Project Name and Address  
 NW DESPAIN AVENUE  
 RECONSTRUCTION PROJECT

NW 5TH ST. TO NW 4TH ST.  
 UTILITY CONFLICTS

Project NW DESPAIN AVENUE	Sheet 3
Date APRIL 2022	
Scale 1" = 30'

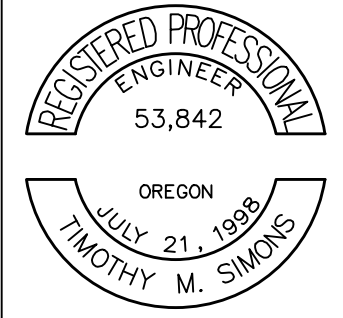
PACIFIC POWER TO RELOCATE UTILITY POLE PRIOR TO PROJECT. MOVE A MIN. OF 4FT TO THE NORTH MEASURED FROM ROAD SIDE OF UTILITY. NEW POLE LOCATION NEEDS TO BE OUT OF PEDESTRIAN PATHWAY AND FOLLOW ADA STANDARDS.

PACIFIC POWER TO RELOCATE UTILITY POLE PRIOR TO PROJECT. MOVE A MIN. OF 6FT TO THE NORTH MEASURED FROM ROAD SIDE OF UTILITY.
